Glacier Highway Extension PROJECT No. 69583

AS-BUILT PLANS

STATE OF ALASKA
DEPARTMENT OF TRANSPORTATION
& PUBLIC FACILITIES
SOUTHEAST REGION

TYPICAL SECTIONS

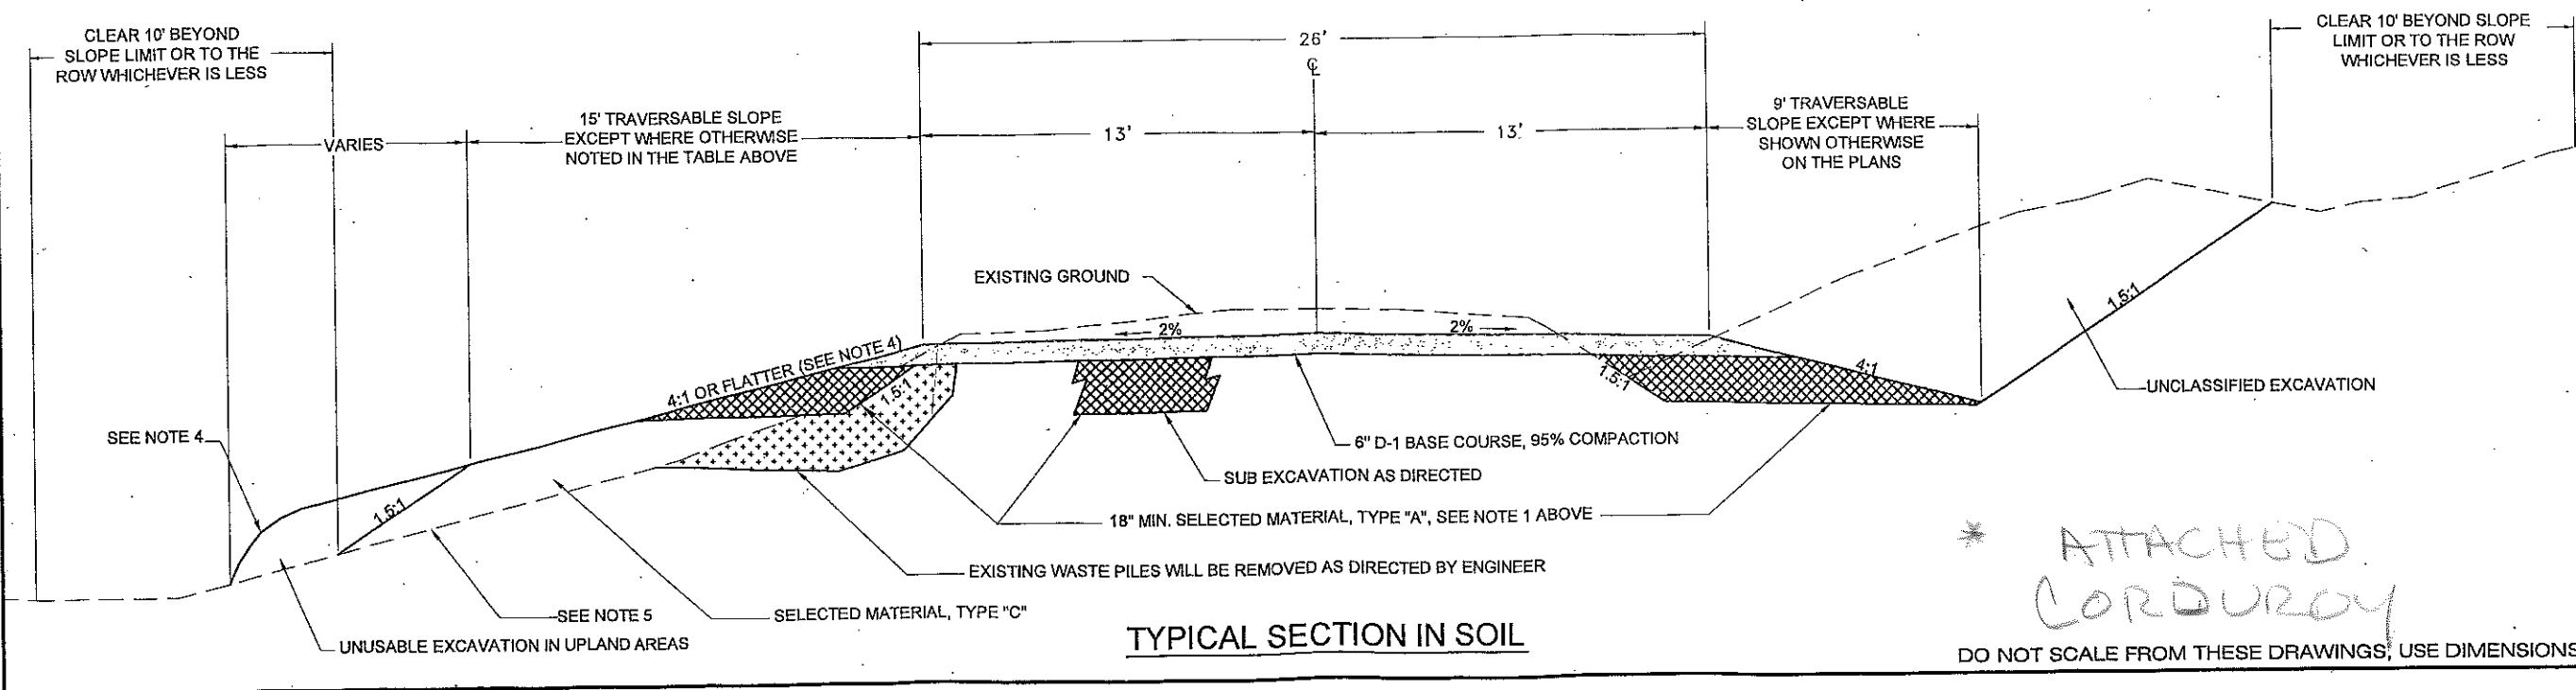
* ATTACHED
CORDUROY

ACTUAL FIELD CONDITIONS

SO FINAL TYPICAL CROSS SECTION LOOKED MORE LIKE.

①

IF NEW GRADE ABOVE EXISTING RD.
CUT OUT ONLY ENOUGH TO HAVE AVG
12" SELECT MATERIAL TYPE "A"
6" D-1 BASE

②

IF NEW GRADE BELOW EXISTING RD
CUT OUT CORDUROY TO HARD PAN OR
ABOUT 4' DEPTH. EMBANK WITH TYPE A.

603 CULVERT PIPE SUMMARY

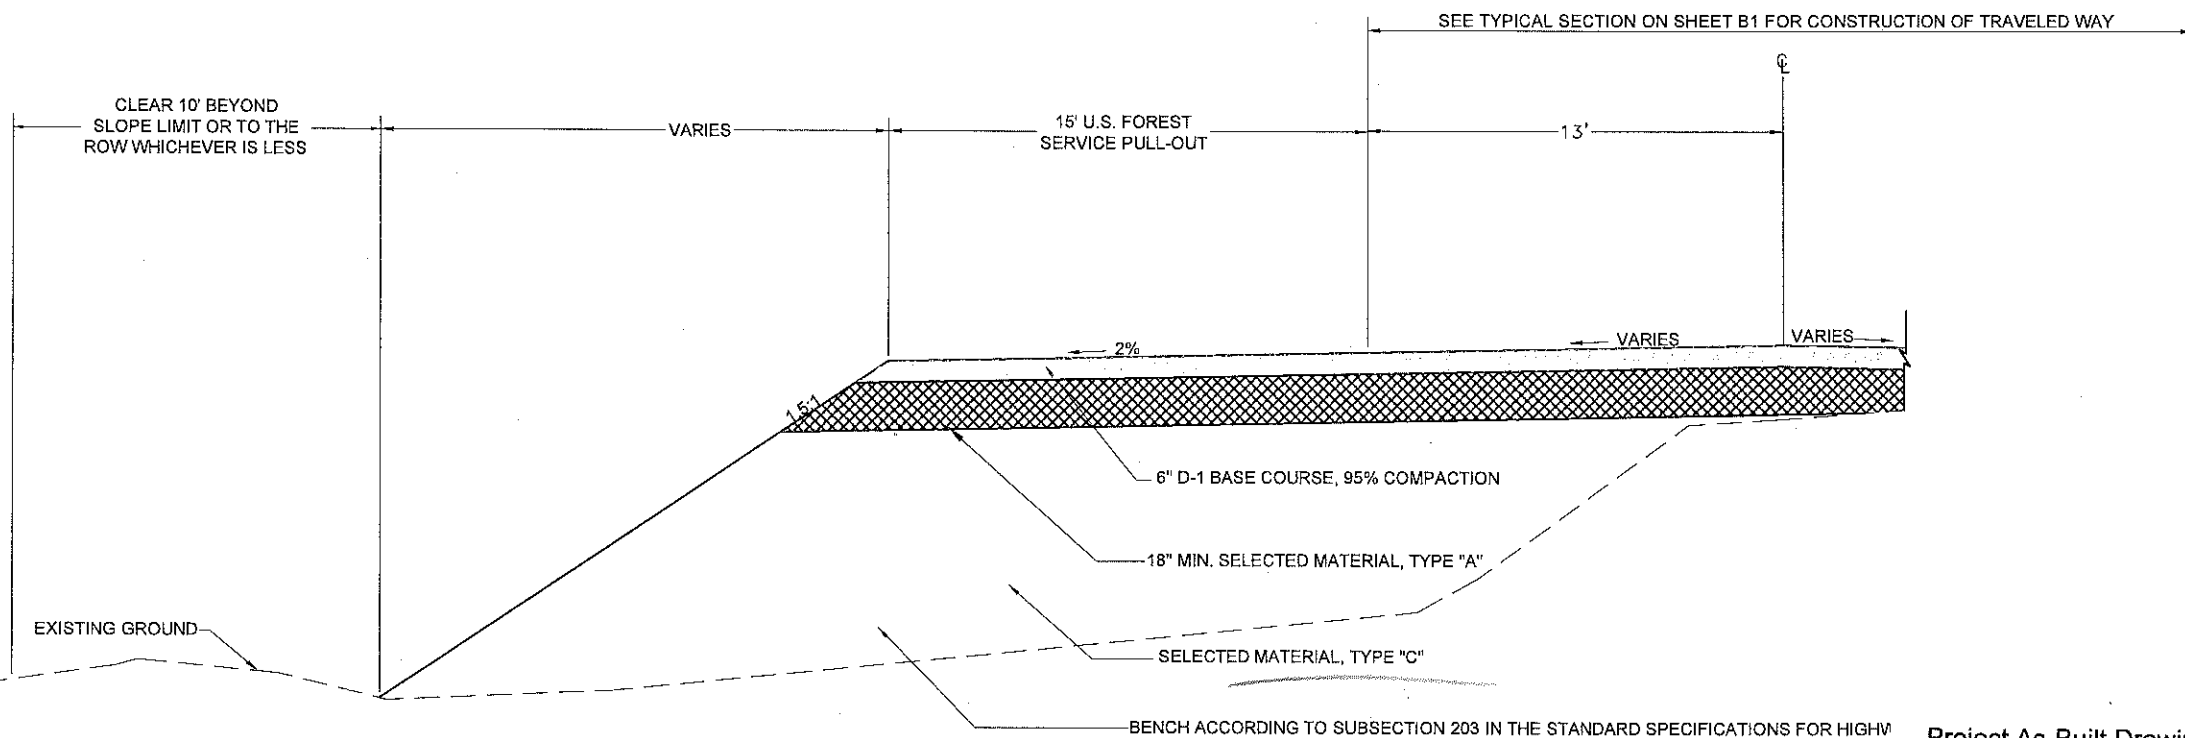
* VERIFY SLOPE %

GATE DETAIL

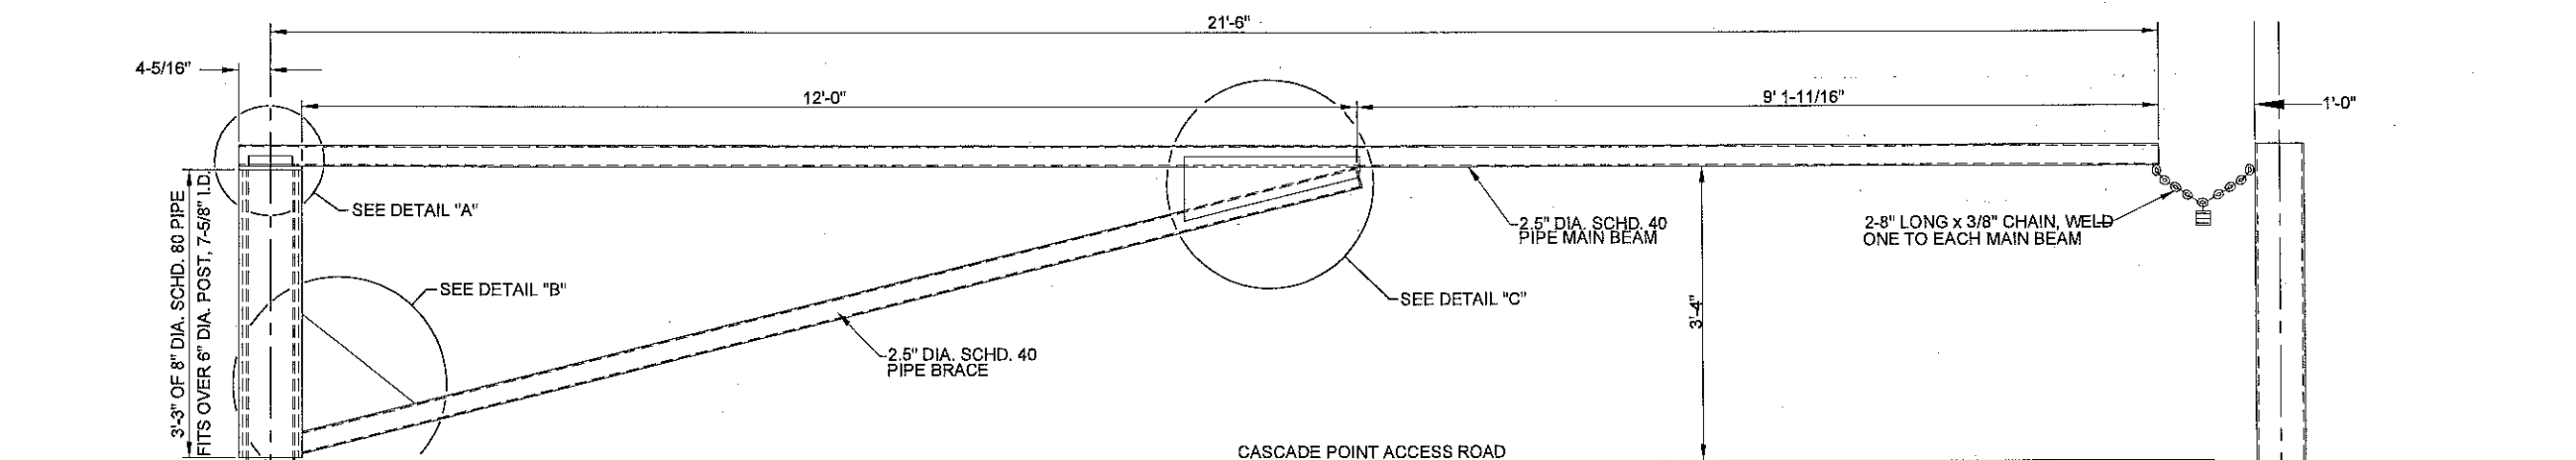
NOTE: AS BUILT OF GATE FOR INFORMATIONAL PURPOSES
